Mask Set Errata for Mask 2M25D

This mask set errata applies to the mask 2M25D for these products:

- MC68HC908AP64
- MC68HC908AP32
- MC68HC908AP16
- MC68HC908AP8

Figure 1. Typical ADC Error Count

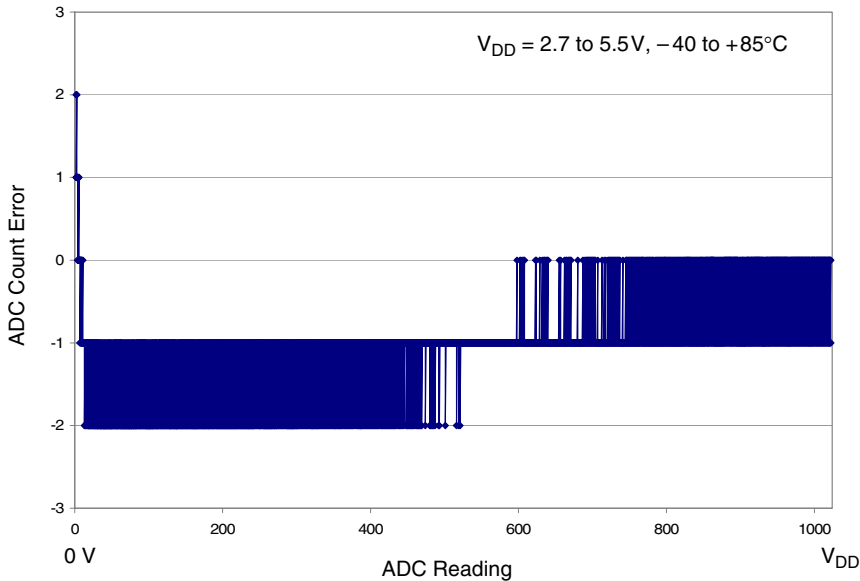
The 10-bit ADC conversion result for 0V input (zero input reading) is \$000, \$001, \$002, or \$003; not the specified \$00 or \$01. With inputs of 5mV and above, the ADC is within the specified accuracy of ± 1.5 LSB (see [Figure 1](#)).
